Docket Number 14-21

The Nature Conservancy (TNC) respectfully submits these comments for the public record on the Draft EIS for the Great Northern Transmission Line (GNTL).

Comment Period: Draft Environmental Impact Statement
 Great Northern Transmission Line
 Docket Nos. E-015/TL-14-21

Map 1
Existing Road & Transmission Corridors
The Nature Conservancy Routing Recommendations
for the Great Northern Transmission Line
 Meredith Cornett, Director of Conservation Science
 June 17, 2013

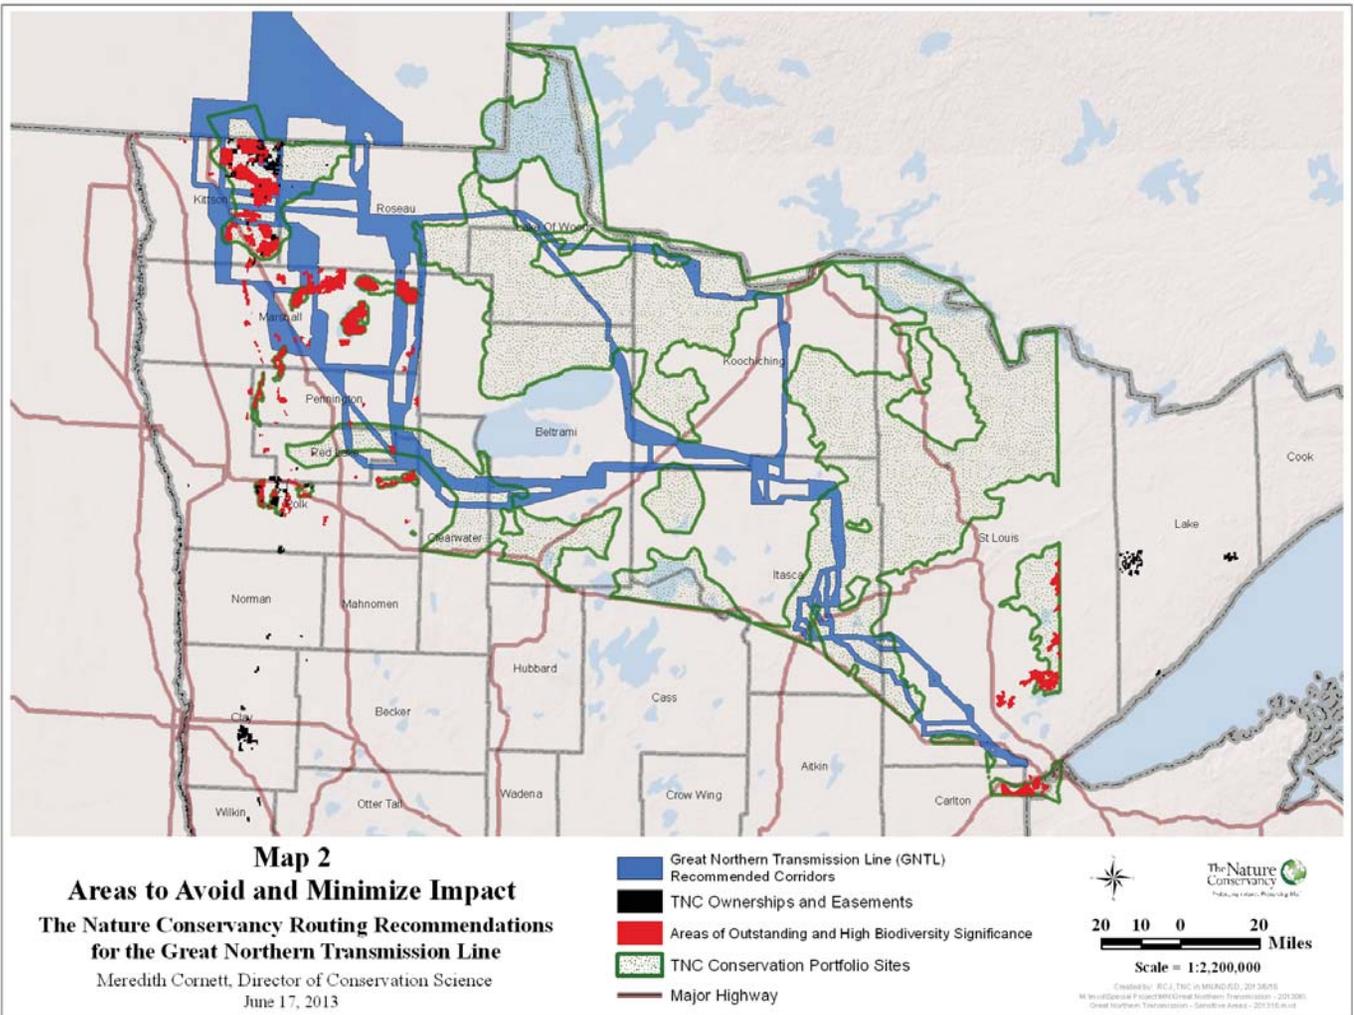
- o Target existing major roads and transmission corridors (Map 1)
 - Overall, TNC favors the Blue Route in the West and Central Sections, as it adheres most closely to the principle of following major roads and transmission corridors, therefore minimizing impacts to critical habitats. In the East Section, neither the Blue nor the Orange Route satisfies this criterion.

1. West Section. At the northern end, the proposed routes miss the opportunities to make use of existing major corridors, such as State Highway 89 or 310 as border crossings and State Highway 11 to travel East. Even more efficient would be to use the existing Border Crossing 500kV Variation and/or the Border Crossing 230 kV Variation.

2. East Section. East Bear Lake Variation Area.
 - We support the Effie Variation in that makes use of the State Highway 65 Corridor.
 - We also support the East Bear Lake and Balsam Variations, both of which make use of existing power corridors.

- East Section. Unfortunately, both the Orange and Blue Routes traverse significant acreage of conservation easements held by TNC on DNR Forestry land in northeastern Itasca County (Segment E1). Please see Map 1 for our preferred route, which makes use of State Highway 1 to traverse east across the northern side of the easement lands and then South on State Highway 65. This is consistent with the Effie Variation identified above.

Additional border crossing alternatives would not address DOE's Purpose and Need to respond to a Presidential permit application. As stated in Section 1.2.2.1 of the EIS, DOE is considering whether or not to issue a Presidential permit for the proposed border crossing contained in the Applicant's October 2014 amended Presidential permit application. The scoping process provided opportunity to recommend alternatives to be analyzed in the Draft EIS. Alternatives to the proposed border crossing under consideration by DOE are presented in the EIS in response to scoping comments from resource agencies and the public, however, those alternatives are included for the purposes of analyses only.

No changes are made to the EIS in response to this comment.

Figure E-2: Northern Area Study Transmission Options

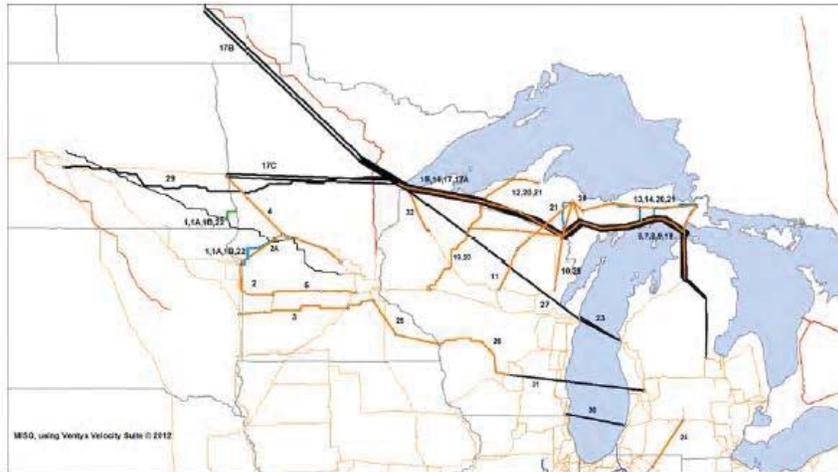
- MISO reviewed this project in the Northern Area Study which was to extend over the UP into Michigan, and not terminate at Blackberry. See GNTL Application.

- A statement that this project has anything to do with regional need is false as the line as proposed in the application terminates in Blackberry, Minnesota, and any reference to regional need should be removed.

No changes are made to the EIS in response to this comment.
